ATTN: EMERY/JOHNS VALLEY GROUNDWATER RESOURCES AND APPROPRIATION POLICY

The following comments are submitted pursuant to the publication by the Utah Geological Survey (“UGS”) of Special Study 172, titled “CHARACTERIZATION OF GROUNDWATER IN JOHNS AND EMERY VALLEYS, GARFIELD AND KANE COUNTY, UTAH, WITH EMPHASIS ON THE GROUNDWATER BUDGET AND GROUNDWATER-SURFACE WATER INTERACTION (herein, “UGS study” or “study”),¹ and also in response to the presentations made by personnel of the UGS and the Utah Division of Water Rights (“DWRi”) at a public meeting held in Panguitch, Utah, on November 14, 2024.

These comments have been prepared and are submitted Bill Loughlin, P.G., of Loughlin Water Associates, LLC, and Kerry Carpenter, P.E., of Carpenter Consulting, LLC, in behalf of several interested entities including Bedrock Water Company, LLC; KB Cedar, LLC; and Samuel M. Smith.²

Figure 1: UGS Study Figure 15 / Public Meeting Presentation Image

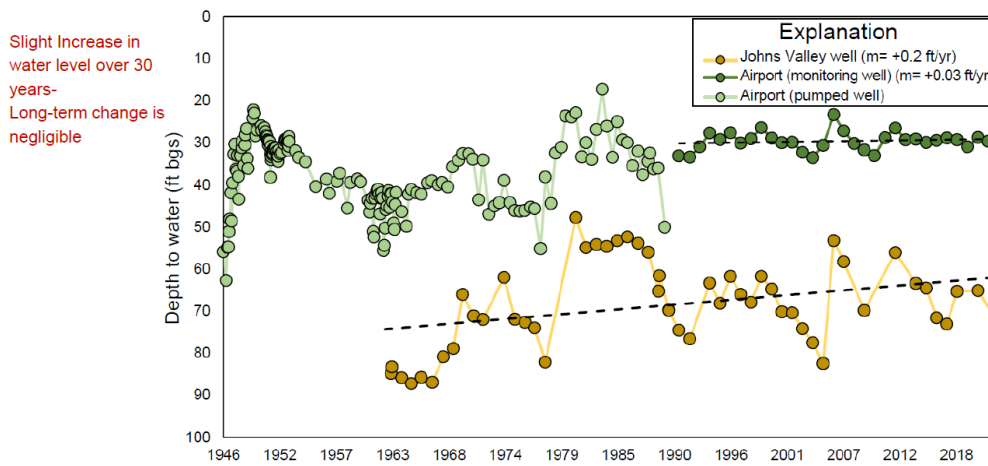
- A related question: What do the long-term *upward or level* trends in water levels in the two U.S. Geological Survey (“USGS”) observation wells indicate about long-term changes in groundwater storage and sustainable yield of the VFA and bedrock aquifers?⁸

Figure 1, below, is a replication of Figure 15 from the UGS Study (pg. 30), as annotated (red text) and presented in the UGS presentation of November 14, 2024. The depicted hydrographs clearly indicate stable or rising groundwater levels over several decades.

Figure 2: Plot of publicly-available water level data for Ruby’s Inn wells

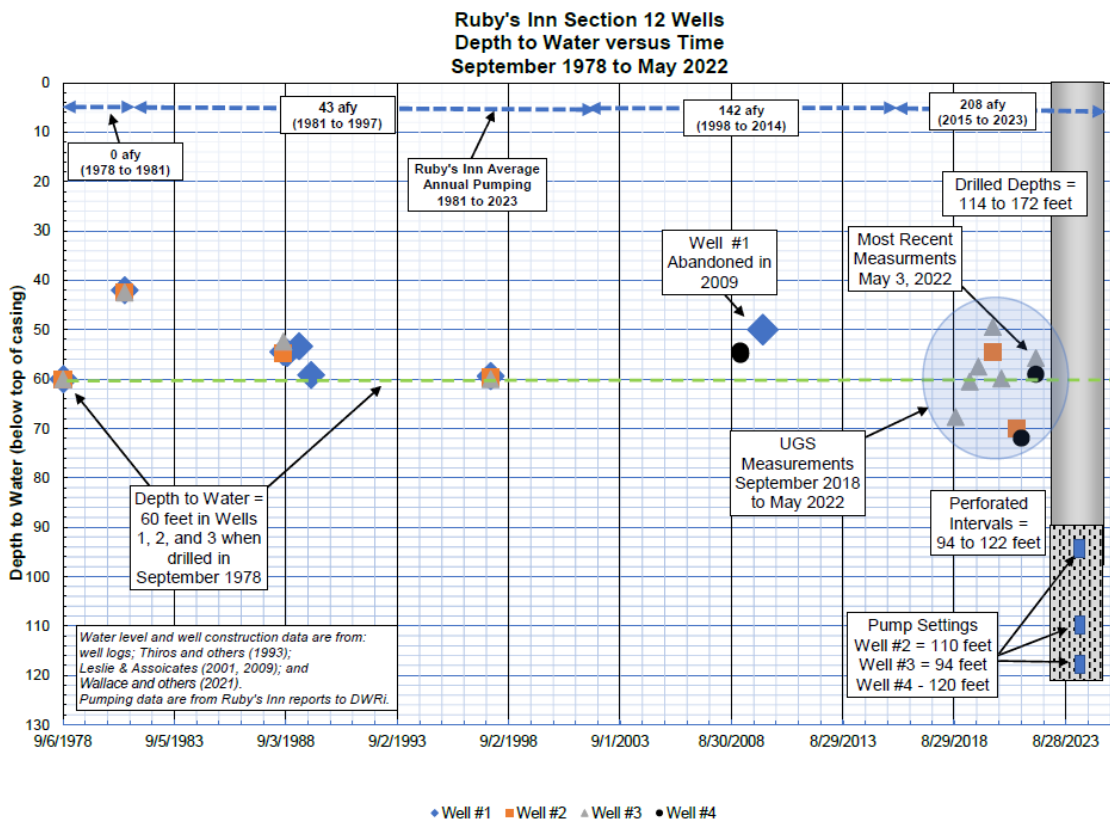
- Further, what does the lack of a downward trend in groundwater levels in the Rubys Inn wells (UGS Site ID #s BC20W, BC21W, and BC22W) in Section 12, T36S, R4W, SLB&M, despite large and increasing groundwater withdrawals, indicate about changes in groundwater storage in and sustainable yield of the VFA?

- Sustainable long-term withdrawals which have reportedly increased from:
 - 0 acre-feet/year (“afy”) prior to 1981, to
 - 43 afy from 1981 to 1997, to
 - 142 afy from 1998 to 2014, and
 - 208 afy from 2015 to 2023.
- Consistent absence of measured groundwater level declines since the 1970s when the Rubys Inn wells were drilled and the 2018-2022 groundwater level measurements reported in the study. Figure 2, below, shows persistently stable groundwater levels evidently unaffected by the pattern of increasing diversions over the past four decades.

- We believe it is important to understand the probable extent of this the area of high transmissivity in the VFA beyond the Rubys Inn well area, and also what these data indicate about the potential for future groundwater diversions from the VFA.
- To provide context regarding the proportionate importance of these data on the Ruby’s Inn wells, we point out in regard to the data reported in the study’s Table 6 (pg. 60):
 - The most recent publicly reported diversions from these wells cited above represent approximately 60% of the estimated “Pumping Total;”
